**Design Amendment - Proposed Child Care Centre - 291 Sunshine Rd, Tottenham - Australia Light Foundation Inc**

**291 Sunshine Road**  
**Addressing Mobil Oil Provisions**

# PROPOSED CHILDCARE CENTRE

## 291 SUNSHINE RD TOTTENHAM

PROJECT	TITLE	DRAWN	SCALE	PLOT DATE	JOB No.
PROPOSED CHILDCARE CENTRE 291 SUNSHINE RD TOTTENHAM	PROPOSED FLOOR PLAN - L00	SS	1 : 100 @ A1		834
		DWG No.	REVISION		
		TP101	M

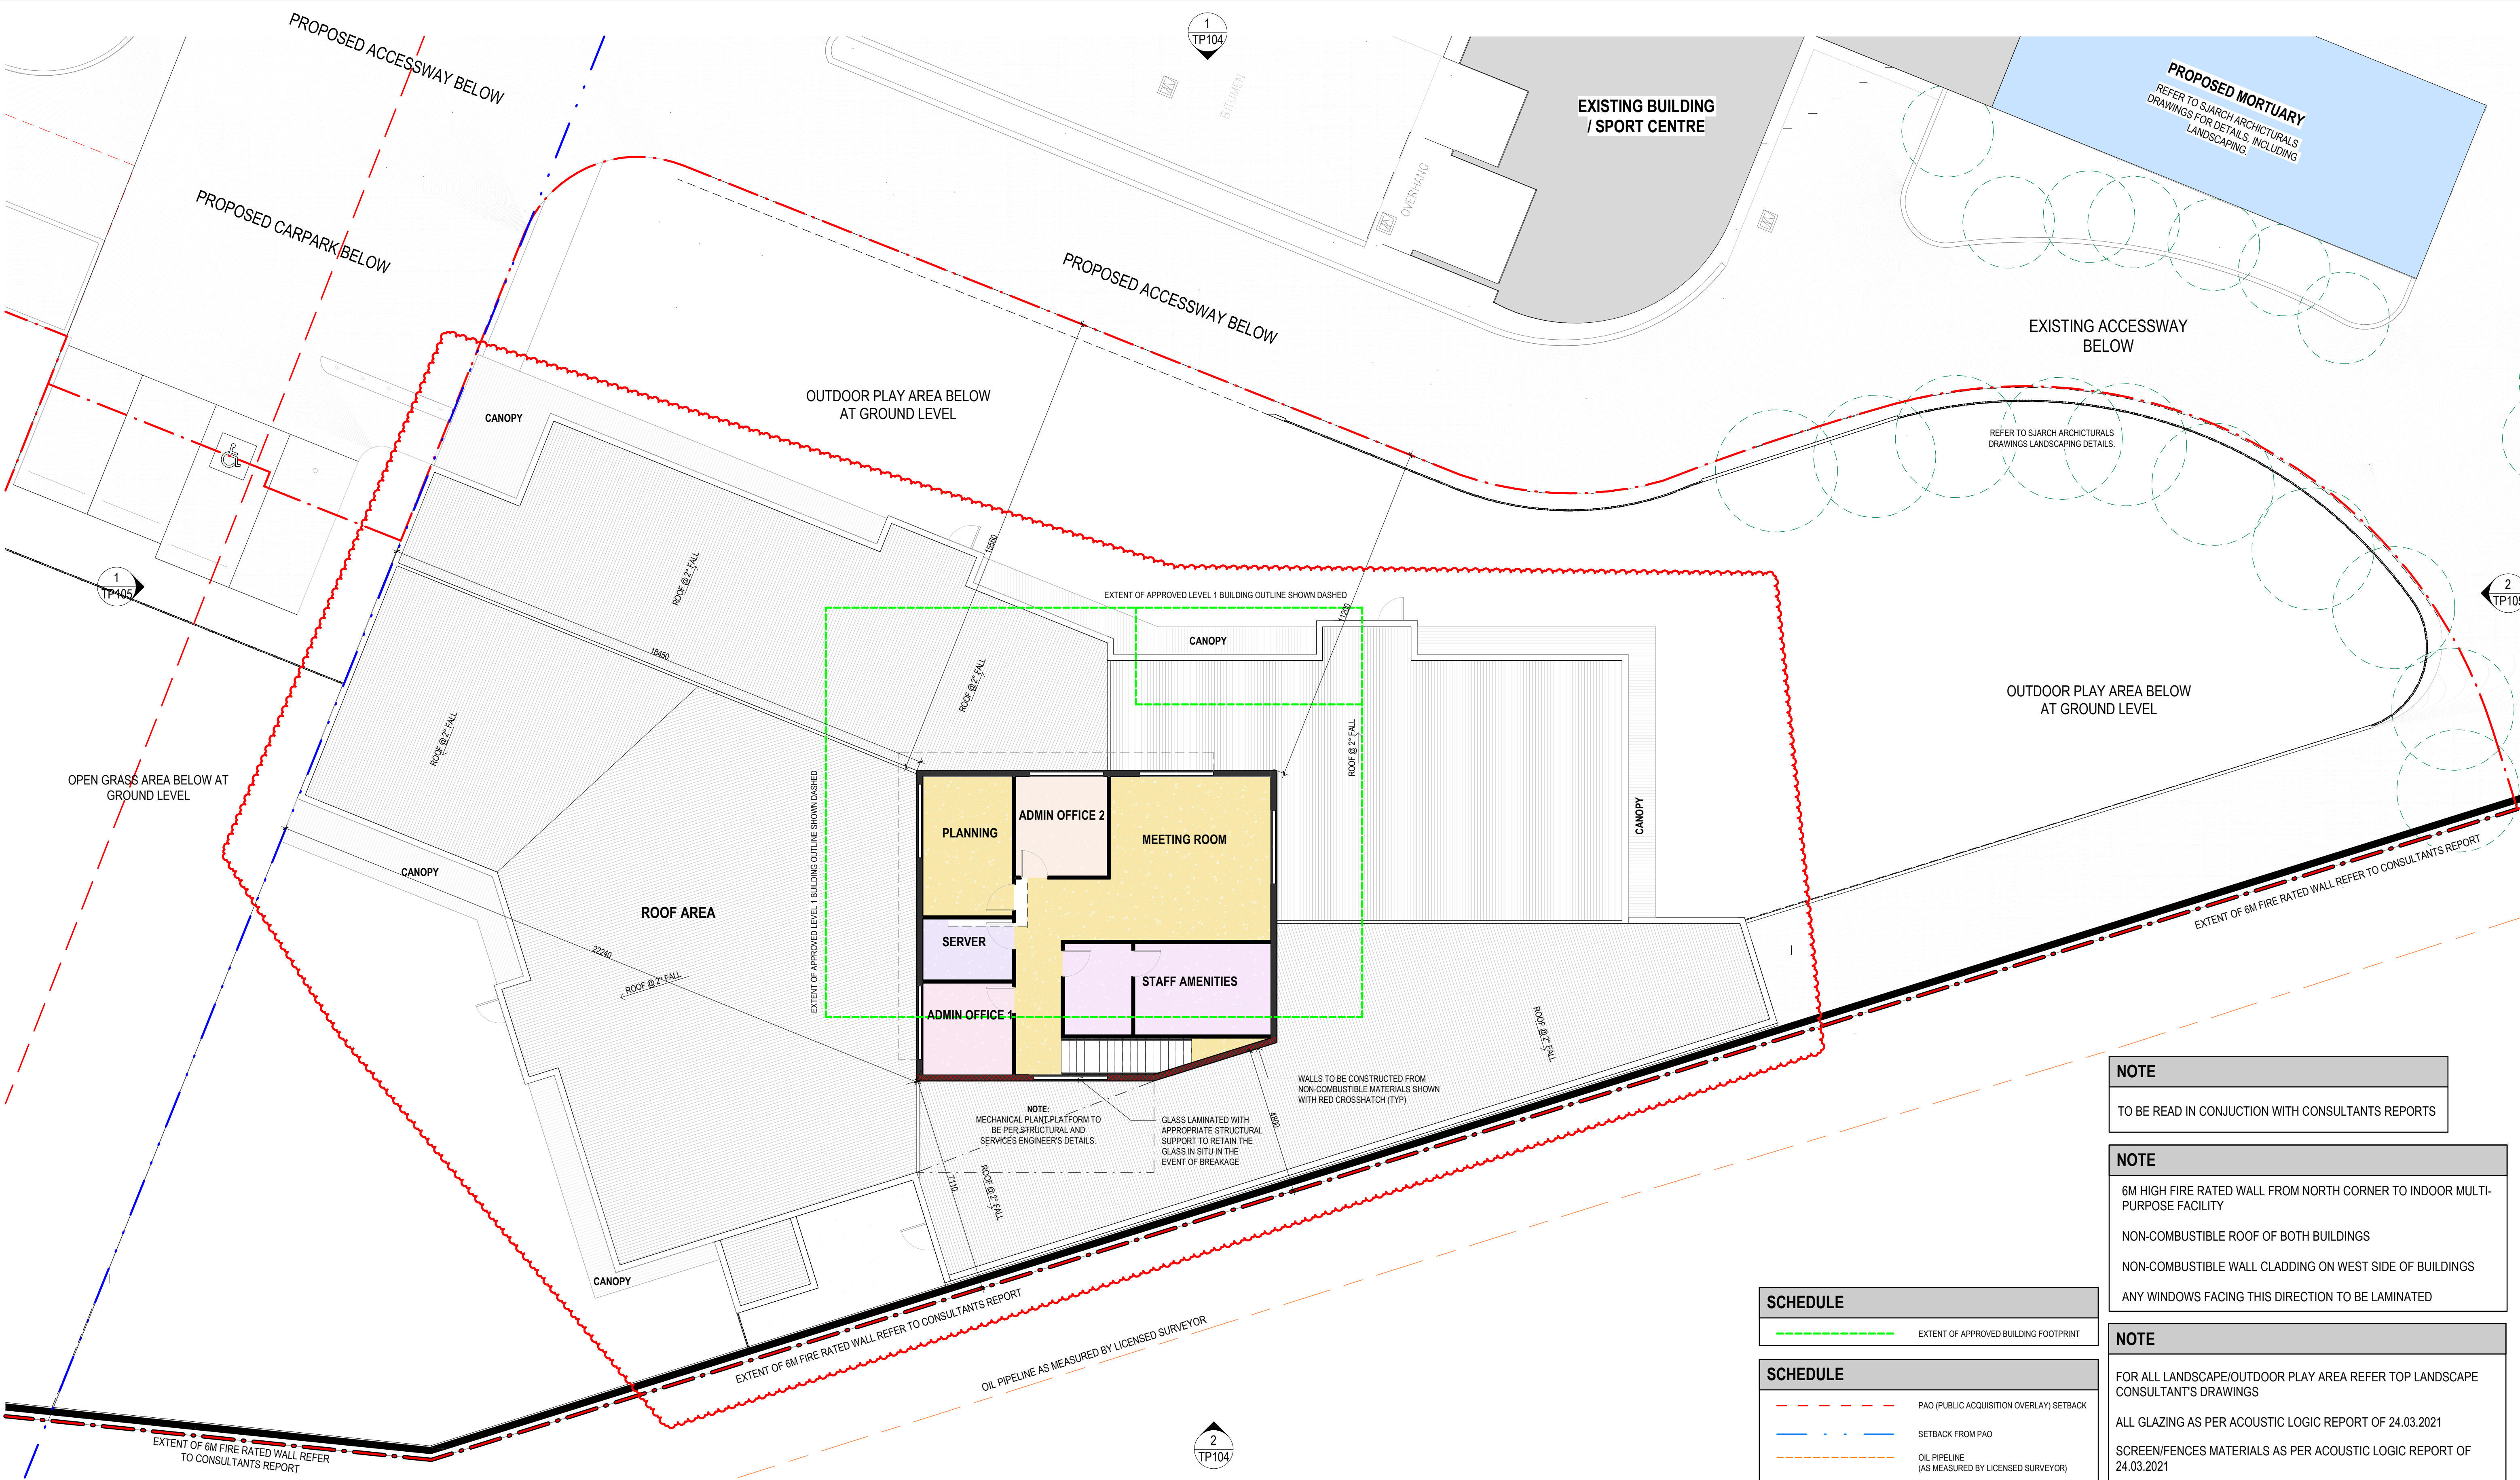
Please note that by incorporating the changes to conditions 23 and 26, your client will also need to prepare (by reason of condition 1d) updated plans that implement Mr Cann's recommendations for relocating the doorways from;

- (a) Playroom 02 to outdoor play area 02 so that it is "as far away from the wall as practicable"; and
- (b) Playroom 06 to outdoor play area 01 so that it is on "the north-east facing wall".

- a) The doorway between Playroom 02 and outdoor play area 02 has been moved as far away as practicable from the fire wall
- b) The doorway between playroom 06 and outdoor play area 01 has been moved to the northeast facing wall
- c) The drawings have been marked up with the requirement that southwest facing windows shall have "glass laminated appropriate structural support to retain the glass in situ in the event of breakage"
- d) The drawings have been marked up with "walls to be constructed from non-combustible materials shown with red crosshatch" for the walls facing the southwest."
- e) The drawings have been noted with the instruction that roof is to be constructed with non-combustible materials.

I confirm that I am satisfied with these changes and that they meet the requirements of my Risk Assessment Report dated 12 March 2025. I can see no reason why you cannot agree to the amendments to conditions 23 and 26 that Mobil Proposes.

Figure 4-7: Radiation Exposure 5/D weather condition play area 2

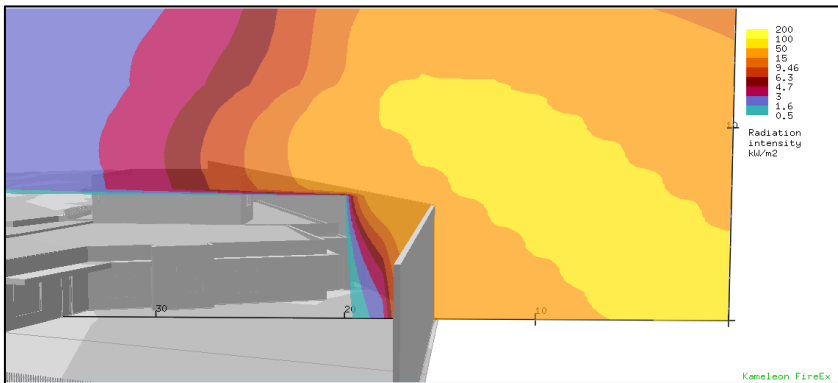
It is observed that there are significant levels of exposure to radiation, particularly of concern for play area 2 in the case of a pool fire as indicated by the contours shown in Figure 4-7. The level of radiation that exceeds  $4.7 \text{ kW/m}^2$  under the 5/D weather condition is approximately 5 meters from the wall which is harmful for any occupants within the vicinity.

With respect to the access doors to outdoor play area 02, these fall in the lower radiation zones (less than 4.7 kW/m<sup>2</sup> as displayed in Figure 4.9) and therefore do not require any specific fire protection. It would be preferable to move the doorway to playroom 02 to the opposite side of the room away from the wall as far as practicable.

Figure 4-5: Radiation Exposure from previous design

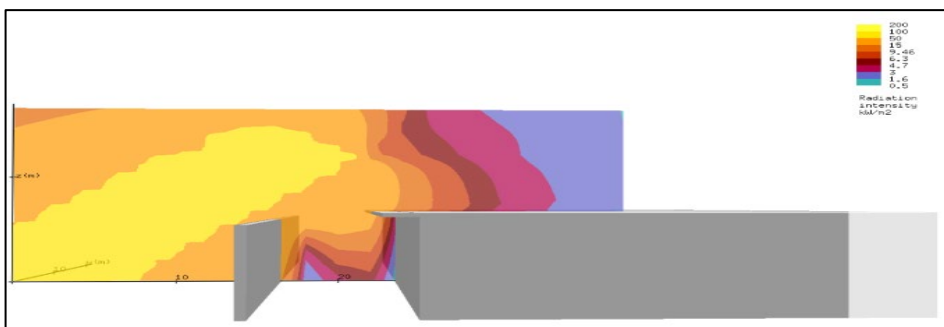
As discussed in section 2, the new design is a better design in the lens of an emergency evacuation situation. This is because the corridor pathway where exposure is highest has been eliminated and occupants now move directly away from the wall towards the entrance of 291 Sunshine Road. Figure 4-8 below depicts radiation exposure from the previous design under a 5/D weather scenario.

**Figure 4-9 Radiation exposure on play area 1 at varying elevations top-down view**

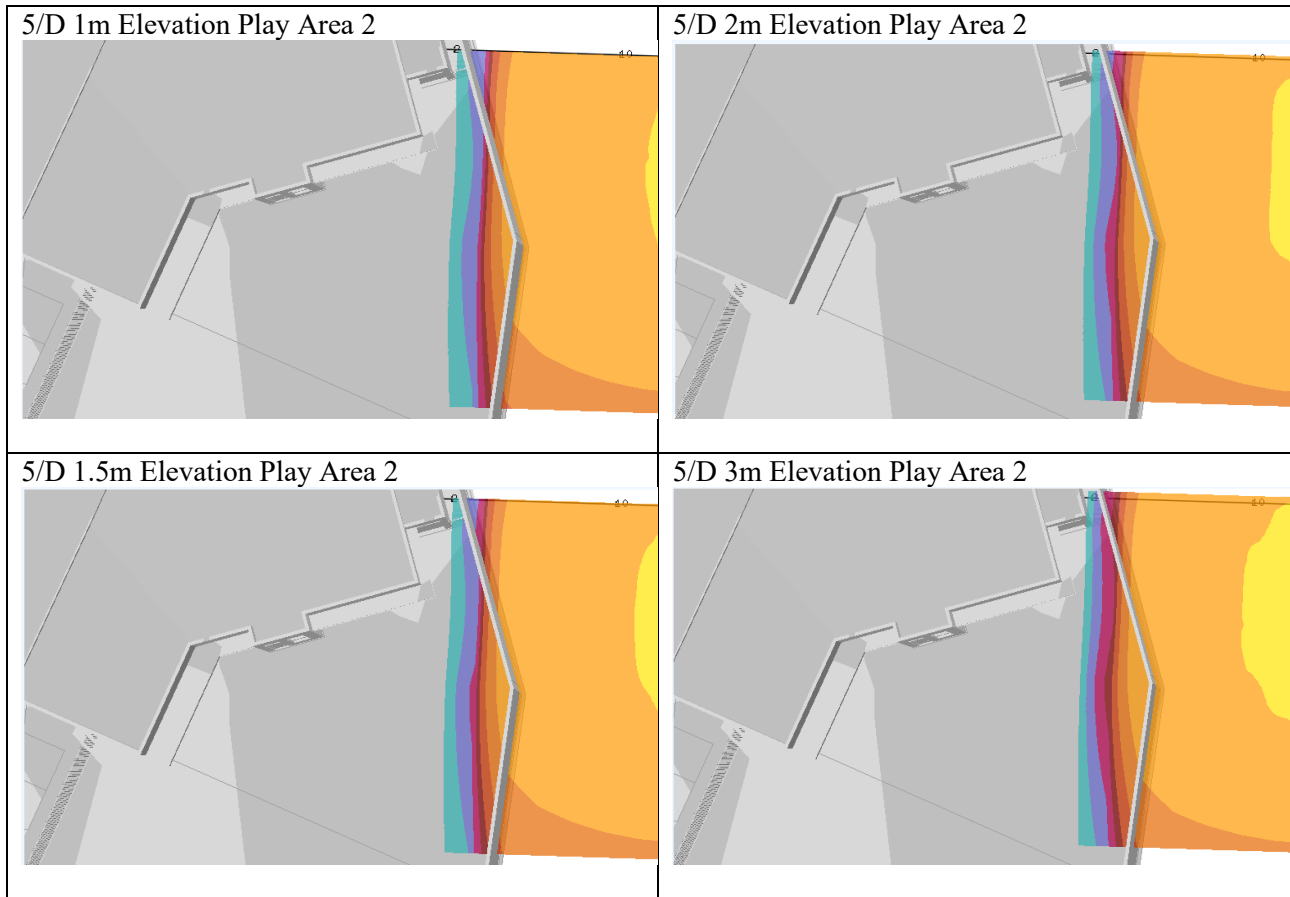
Figure 4-9 aims to illustrate the area of radiation experienced as a function of various heights with the most significant being 1.5m as occupants are typically small children.
